PRODUCT/PROCESS CHANGE NOTICE (PCN)

PCN #: TB0609-03R1 Product Affected: All square PQFP and TQFP, MLP Dual, QFP-N, VFQFP-N packages shipped in Tape and Reel Date Effective: 2-Apr-2007	DATE: 11-Jan-2007	MEANS OF DISTINGUISHING CHANGED DEVICES: <input type="checkbox"/> Product Mark <input type="checkbox"/> Back Mark <input type="checkbox"/> Date Code <input checked="" type="checkbox"/> Other Starting 2-Apr-2007
---	---------------------------------	---

ATTACHMENT I - PCN #: TB0609-03R1

FROM:

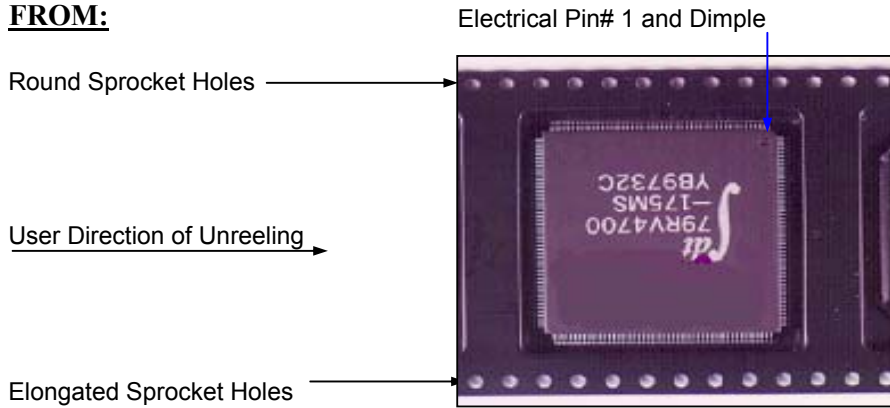
- PCN Type:** To comply to current EIA Standard (EIA-481-C) requirement.
- Data Sheet Change:** No
- Detail of Change:** This change will be implemented on all square PQFP and TQFP, MLP Dual, QFP-N, VFQFP-N packages.
- Affected Packages:**
